ADDENDUM 1

Date: March 27th, 2023 **Addendum #:** 1
Project: MSU NAH 360 Lab and 324 Lab Renovation
Project #: 202141
To: All Plan Holders of Record

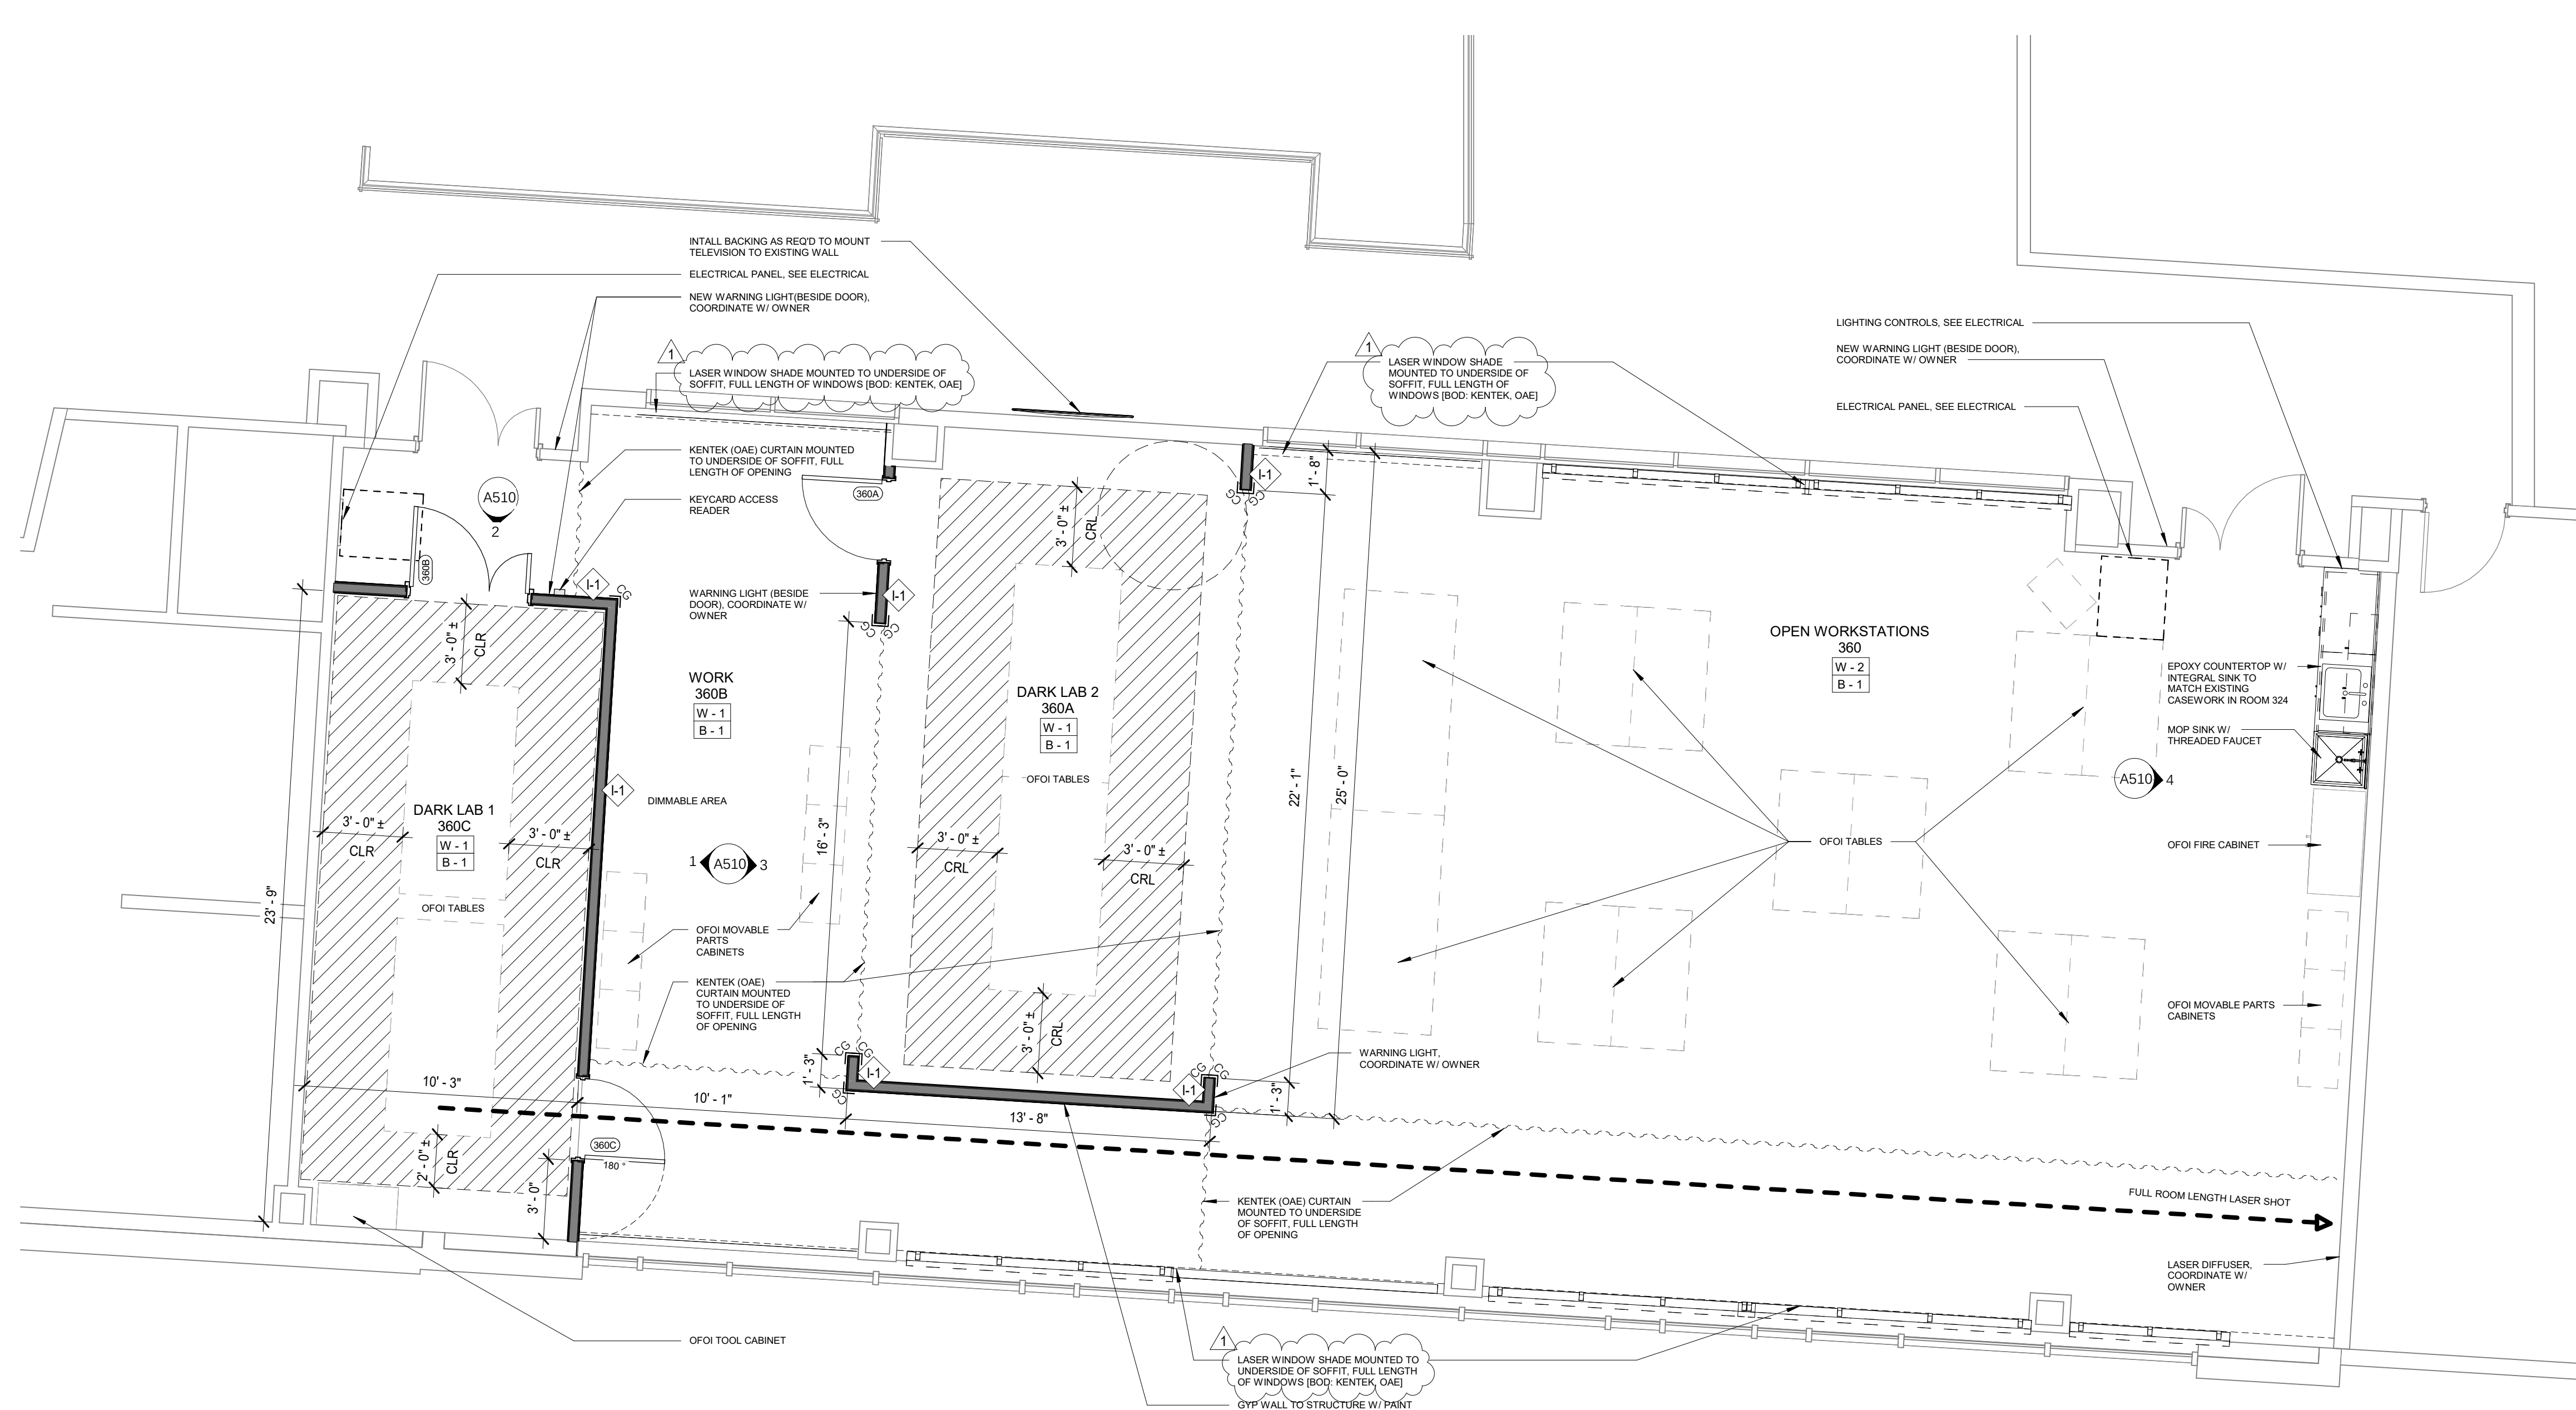
- Q1. After reviewing specifications 12 24 00 and 12 24 10 and the drawings, we see curtain call-outs on the drawings but not shade callouts. Please clarify locations and types of windows/room treatments.
- C1. Motorized laser shades are on the exterior and corridor windows. The laser curtains are on a track system and manually pulled. Reference to window shades vs curtains have been clarified in drawings A210 and A230. Both systems are covered in their respective spec sections and have been updated in the drawings and not owner provided, so are part of the bid.**

- 1) SHEET A210 – FLOOR PLAN: this sheet in its entirety with the sheet attached. Modifications include;
 - a. References to 'LASER CURTAINS' at windows revised to indicate 'LASER WINDOW SHADES'
- 2) SHEET A230 – ROOM 360 REFLECTED CEILING PLAN: this sheet in its entirety with the sheet attached. Modifications include;
 - a. References to 'LASER CURTAINS' at windows revised to indicate 'LASER WINDOW SHADES'
- 3) SHEET A510 – INTERIOR ELEVATIONS & DOOR SCHEDULE: this sheet in its entirety with the sheet attached. Modifications include;
 - a. Valence panel added to Wall Cabinet W-1 to cover integrated cabinet lighting.
